January 14, 1992
LD-92-001

Docket No. 52-002

Subject: Response to NRC Requests for Additional Information

RESPONSE TO NRC REQUESTS FOR ADDITIONAL INFORMATION
ELECTRICAL SYSTEMS BRANCH

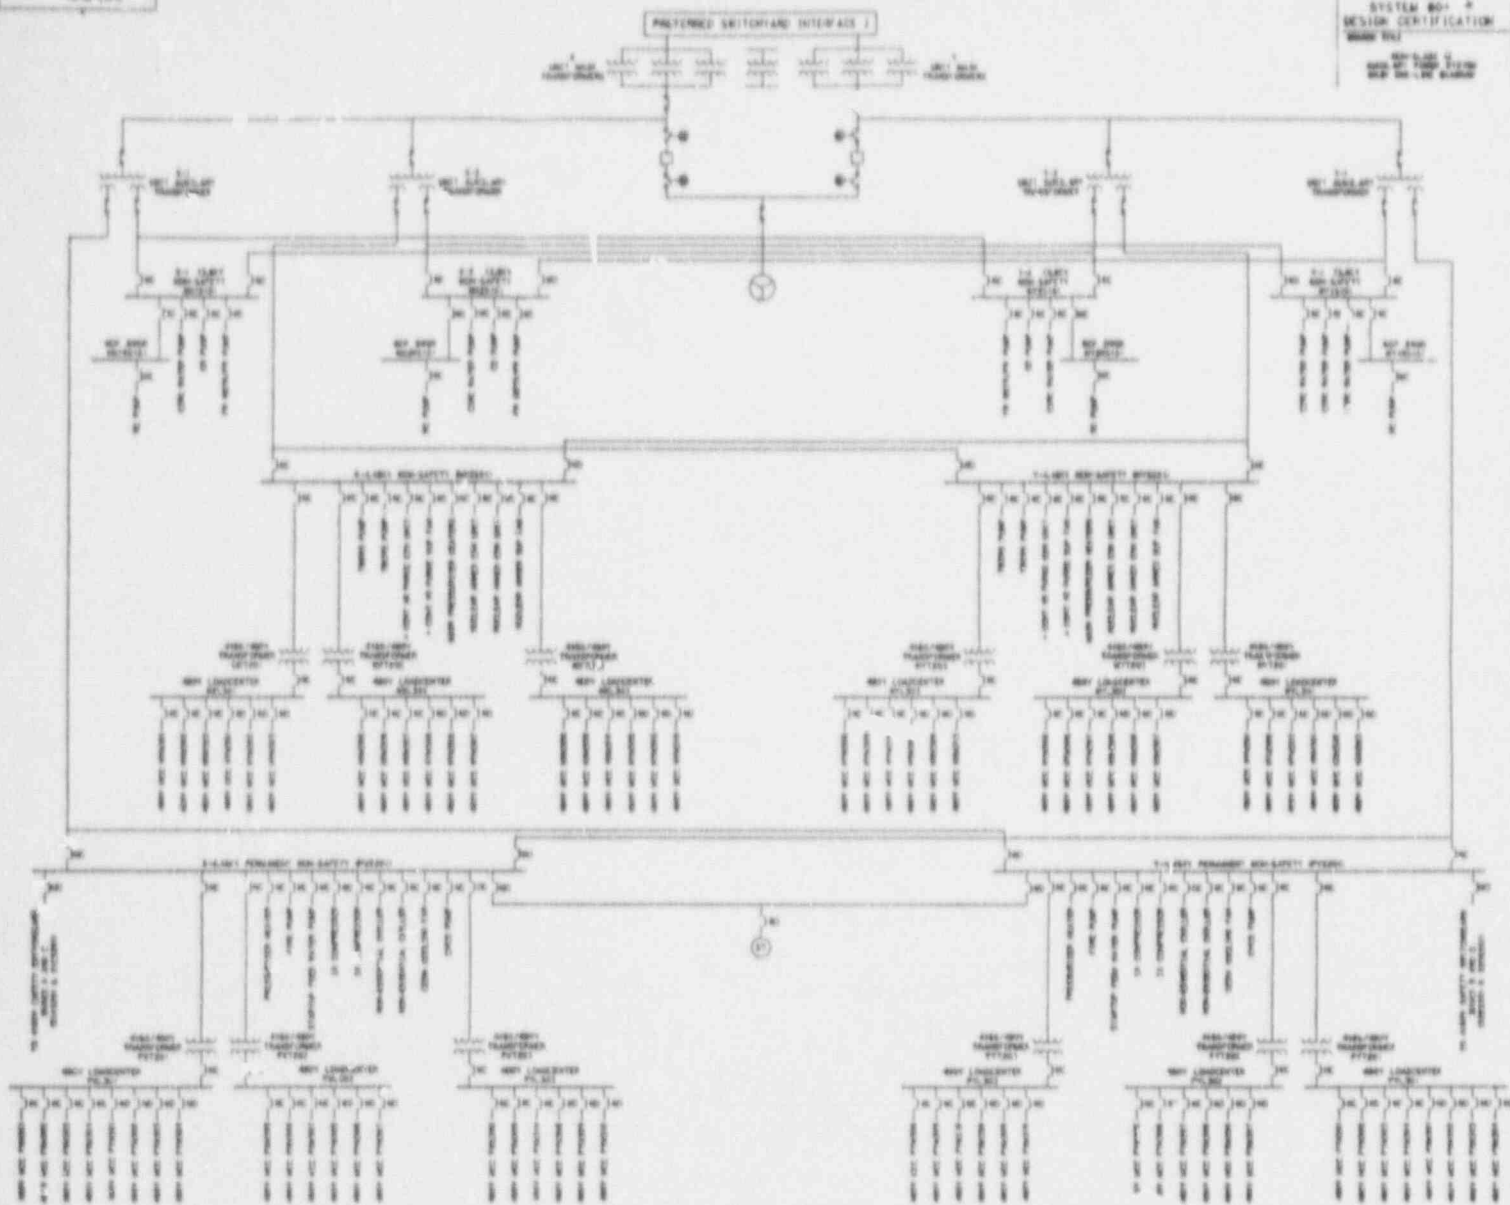
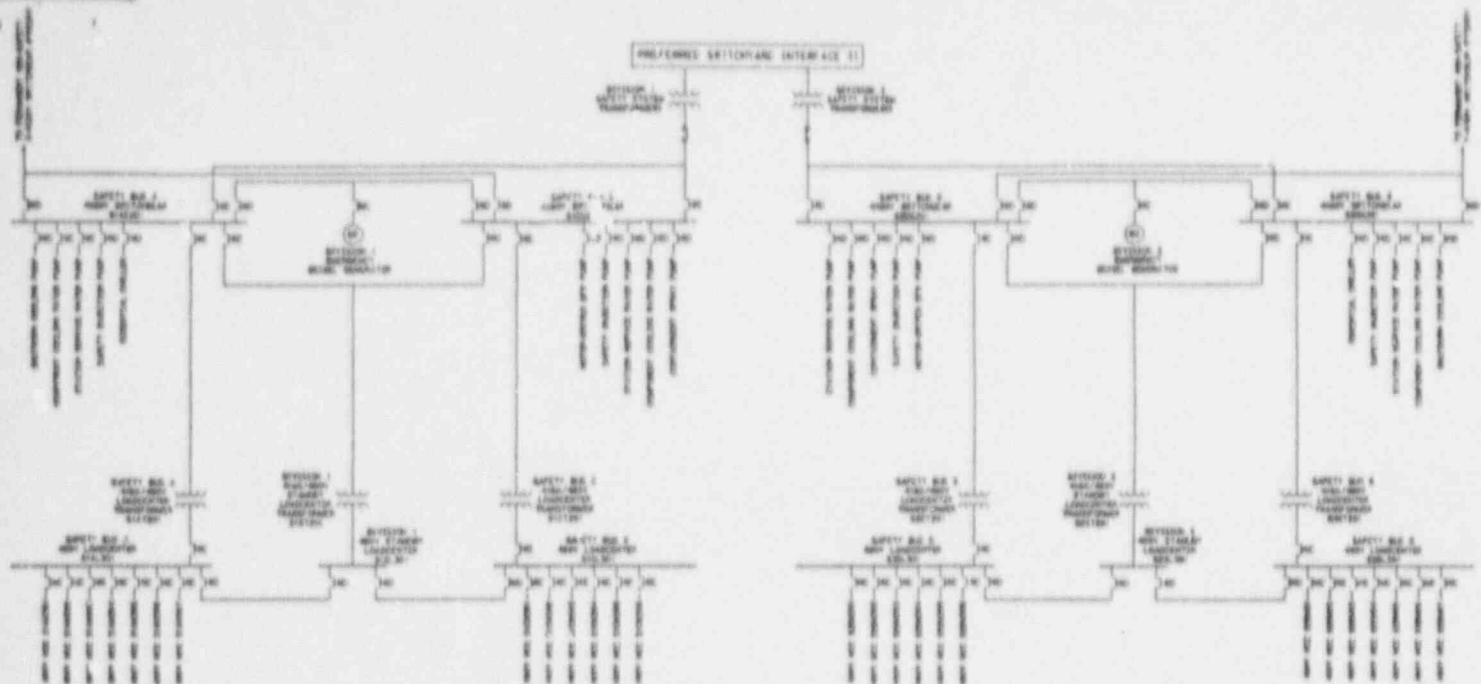
There is no interface criteria provided for the location of standby auxiliary transformer in the SSAR. The staff requires that the standby auxiliary transformer should be separated from the main and unit auxiliary transformer to the maximum extent practical (preferably on different sides of the building) in order to minimize the common effects of fire or environmental effects such as lightning on their operation. Please provide this information.

Figure 8.3.1-1 of the SSAR shows the safety loads normally powered from the unit auxiliary transformers through the permanent non-safety load buses. The unit auxiliary transformer winding that feeds these loads also feed a portion of the non-safety loads. The standby auxiliary transformer also feed the safety buses through the permanent non-safety load buses. In addition, there is a provision (through two circuit breakers in series) to directly feed the safety buses from the standby auxiliary transformer.

Feeding the safety buses from the offsite power sources through non-safety buses or from a common winding with non-safety loads is not the most reliable configuration. It subjects the safety loads to transients caused by the non-safety loads and adds additional failure points between the offsite power sources and safety loads. In order to overcome these shortcomings we recommend that a second standby auxiliary transformer directly supplied from the transmission system be added, with the combination of the two standby auxiliary transformers normally directly powering the safety buses. The existing supply from the unit auxiliary transformer through the permanent non-safety buses to the safety buses should be retained as a manually switched alternate power supply.

Figure 8.3.1-1, the unit main power system one-line, has been revised thereby deleting the standby auxiliary transformer. The new one-line shows two safety system transformers which now directly feed the safety buses. These transformers are physically separated such that no fire nor environmental effect shall disable both the safety and non-safety offsite sources.

The electrical one line, Figure 8.3.1-1, has been revised to show that the safety buses can be fed directly from an offsite power source. That figure also shows that the safety buses could be fed from the non-safety buses. As discussed at the November 20, 1991 meeting with the NRC staff, the normal supply of power to the safety buses is a site-specific consideration which would include the voltage and reliability of the switchyard source. See the response to RAI 430.9 for CESSAR changes.

Figure 8.3.1-1 Replace with
Drawing E-713-00-01 and
Drawing E-713-00-03

SYSTEM 60-1, CHANNEL 1 AND CHANNEL 2
SLAVE 10, 11, AND 12, 13
AUTOMATED AND CONTROL, POWER SUPPLY SYSTEM

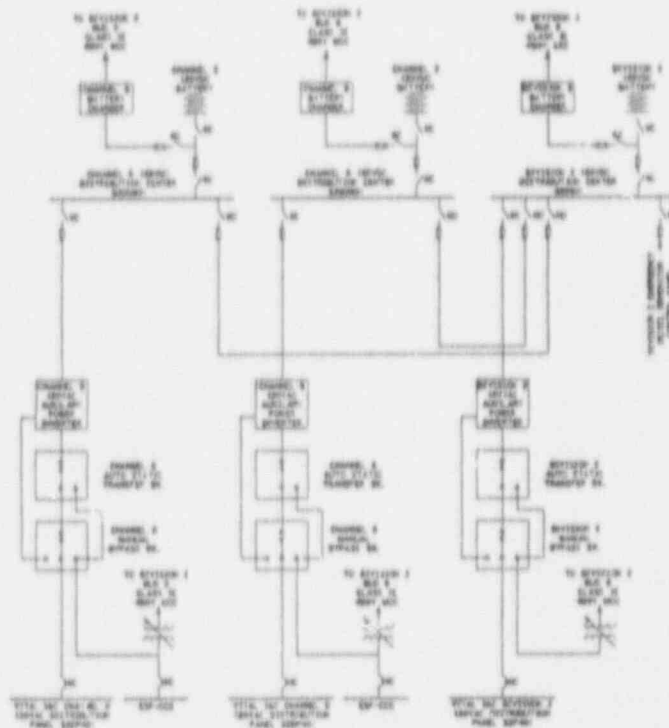
Sufficient system single-line diagrams and schematic diagrams for on-site systems have not been provided in SSAR to permit an independent evaluation of compliance with the safety criteria as required by RG 1.70. Please provide this information including the schematic diagram for Reactor Trip Breaker.

Class 1E DC and Vital AC Instrumentation and Control Power Supply System

Figure 8.3.2-1 Drawing E-713-00-02

Figure 8.3.2-2 Drawing E-713-00-04
